FORM C&GS-504 U.S. DEPARTMENT OF COMMERCE ENVIRONMENTAL SCIENCE SERVICES ADMINISTRATION COAST AND GEODETIC SURVEY	
<h2>DESCRIPTIVE REPORT</h2>	
<i>Type of Survey</i> SHORELINE (Photogrammetric)	
<i>Field No.</i> <i>Office No.</i> T-12179	
LOCALITY	
<i>State</i> Alaska	
<i>General locality</i> Keku Strait	
<i>Locality</i> Turnabout Island	
<hr/> 19 62-1966	
CHIEF OF PARTY	
Alfred C. Holmes, Director, AMC	
LIBRARY & ARCHIVES	
DATE

DESCRIPTIVE REPORT - DATA RECORD
T - 12179

REVIEW REPORT T-12179

ADDENDUM TO REVIEW REPORTS

COMPARISON PRINT

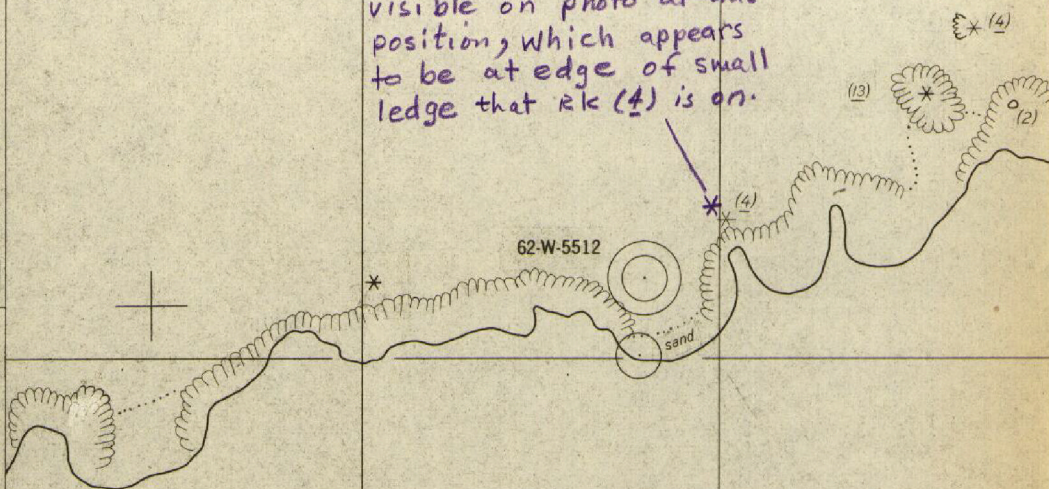
No prominent rock visible on photo at this position, which appears to be at edge of small ledge that Rk (4) is on.

COMPARISON PRINT

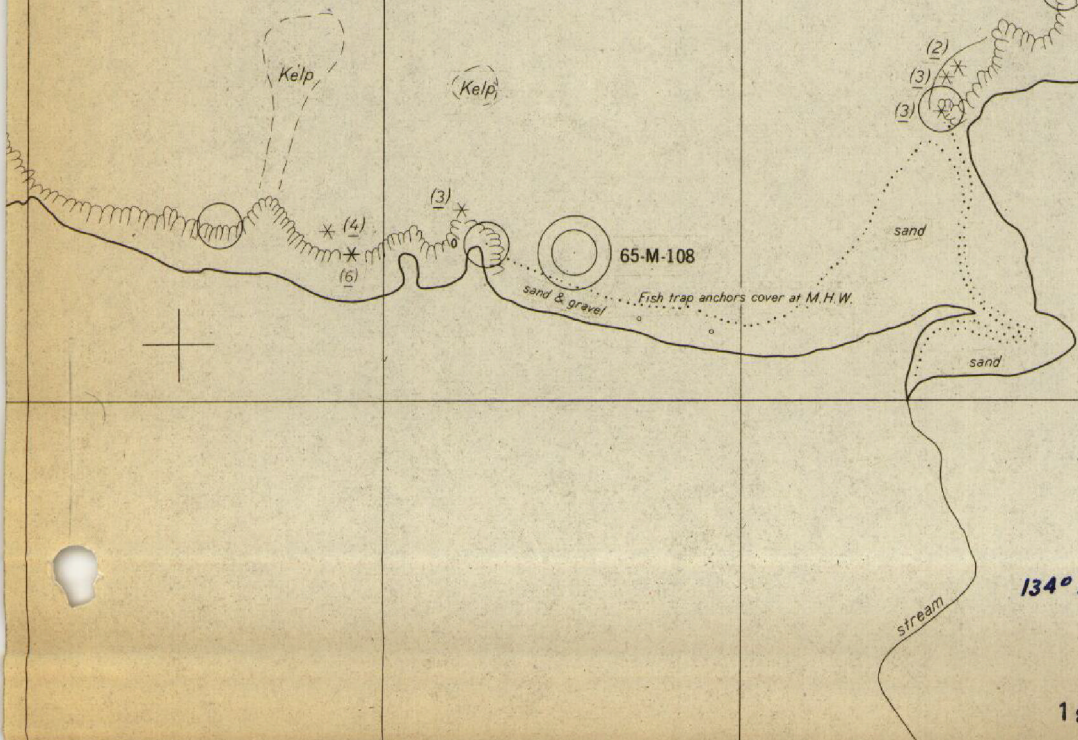
Rocks are part of reef.

Doubtful on photo
